<div>COA # 2014-COA-024 Part B (LS) 2014-VHP-021</div>	<div>INDIANAPOLIS HISTORIC PRESERVATION COMMISSION STAFF REPORT</div>	<div>Hearing Date AUG. 6, 2014</div>
<div>534 E. Michigan St LOCKERBIE SQUARE</div>		<div>Continued from: August 6, 2014 June 4, 2014 May 7, 2014 March 5, 2014</div> <div>Center Twp. Council District 9 Joseph Simpson</div>
<div>Applicant</div>	<div>Dan Jacobs by NDZA, Inc. mailing address: 618 E Market St Indianapolis, IN 46202</div>	
<div>Owner:</div>	<div>North Lockerbie LLC % Intrinzia Family Office 80 S 8th St Suite 1725 Minneapolis, MN 55402</div>	
<div>COMBINED CASE</div>		
<div>IHPC COA:</div>	<div>2014-COA-024 Part B (LS)</div>	<div><ul style="list-style-type: none">• Demolish structure at 534 Michigan St• Construct a four-story multifamily housing development with onsite parking• Variances of Development Standards</div>
<div>VARIANCES:</div>	<div>2014-VHP-021</div>	<div>Variances of Development Standards of the CBD-2 Zoning Ordinance to allow less setback than required from the north and west lot lines (at least 10 ft required/ or no setback)</div>

STAFF COMMENTS

Update from March 5, 2014

REVISED SITE PLAN

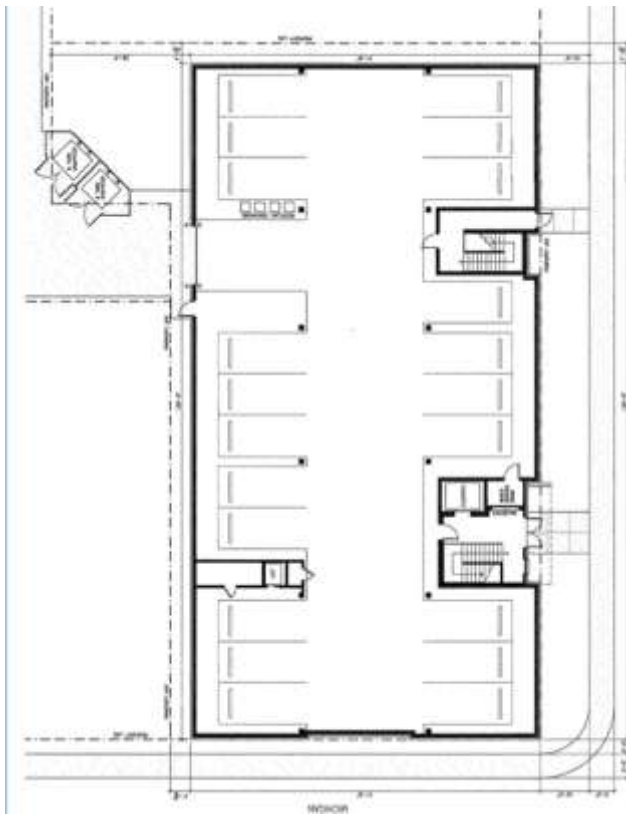
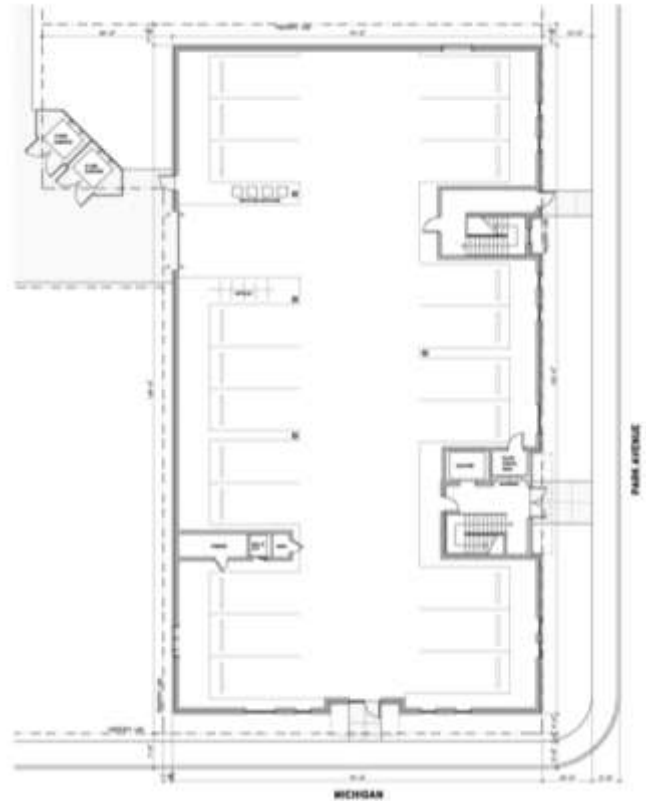
New drawings show the building set back further, and added entrance on the south side, and a lighter colors for the balconies. The window configuration on the south elevation has changed slightly. Staff believes these changes are all positive and address the comments of the Commission.

(note increased setback from Michigan St.)

On the setback, the revised plan appears to line the setback up to the 'grass line' of the house just to the west of the proposed development. That house has the least amount of setback in the block. A quick glance to the house at the corner of Leon and Michigan as well as towards the newer brownstones, shows a much deeper setback. To me, the setback for the revised plan is not deep enough (see, HPP p D32). While the revised plan with an entrance on Michigan has moved closer to an inviting presence, the lack of a deeper setback detracts from that invitation and creates an uneven line of sight down Michigan St. An increased set back with a smaller overall footprint would be much more visually appealing and certainly more consistent with the smaller footprints of the existing homes. Again, the setback seems to be more appropriate if it is lined up with the deeper setback of the house next to Leon St. and the newer brownstones.

REVISED DESIGN
Michigan St. Elevation

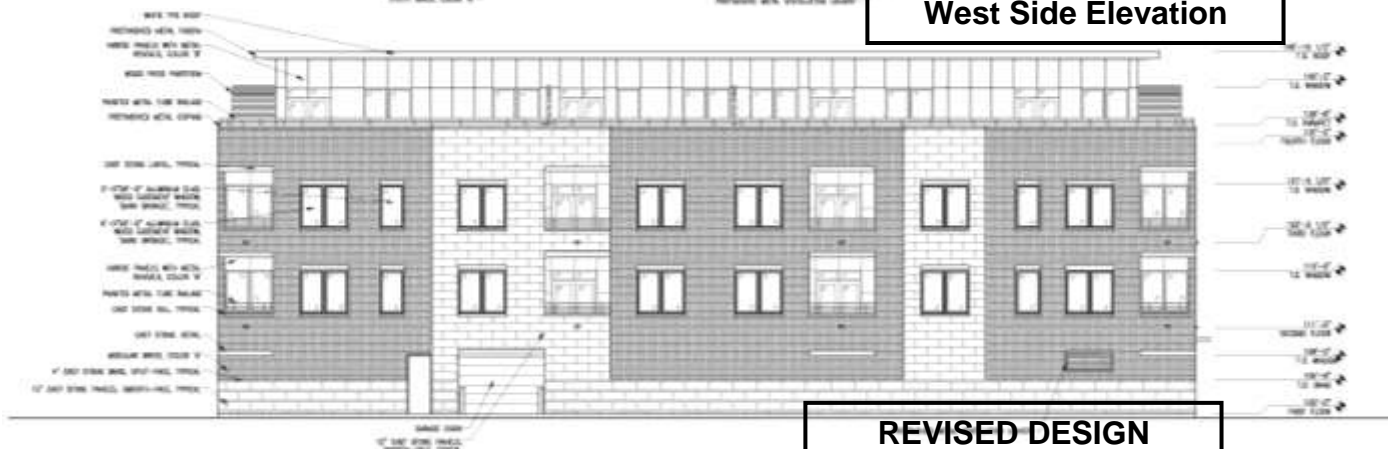
- Adding an entrance to the south Michigan St. elevation
- Including a color rendering
- Setting the front of the building further back from Michigan St.

Views of 534 E. Michigan – Demolition Request

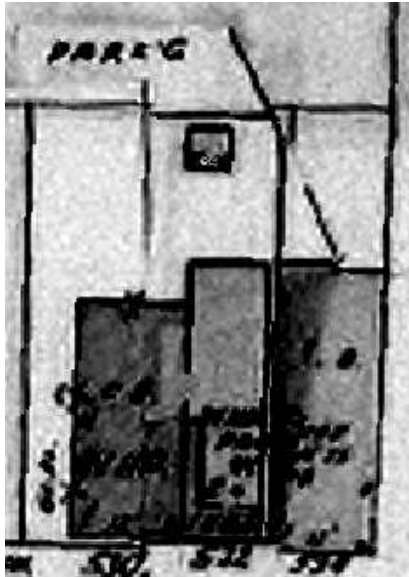
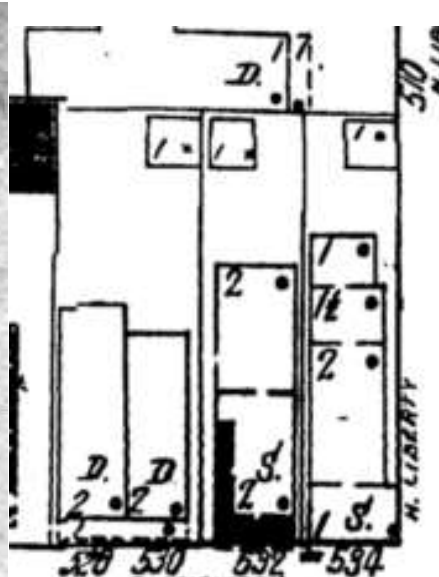
This commercial structure currently houses a mechanical contractors business. The building is a concrete block structure built in

three phases around an 1860's era two-story house. It is one of the oddest re-uses of a historic building that staff has ever seen. Only the second floor of this historic house remains and sits above the flat roof of the concrete block building. Other than the rear wall, the first floor and porch of the house are gone.

1950's. The first phase appears to have been built in the early 1950's replacing the corner house and wrapped around what used to be the front porch of the remaining 1860's house.

After 1956. The two-family dwelling on the west side of the remaining 1860's house was demolished to make way for a second phase of the concrete block structure.

1976. A third phase was constructed as an addition on the back end of the site.

1. Insubstantial Effect. The concrete block portion possesses no significance or architectural merit. Its loss will have an insubstantial effect on the historic area. The frame house remnant does possess some architectural detail and significance, but its loss will be insubstantial because its importance to the character of the historic area was seriously and negatively compromised by the surrounding concrete block building.
2. Hardship. While the second floor of the 1860s house is relatively intact, there is no practical or reasonable way to expect it to be saved when there is no first floor below it. Denial would be a substantial hardship since it would make any practical and reasonable redevelopment of the site almost impossible.
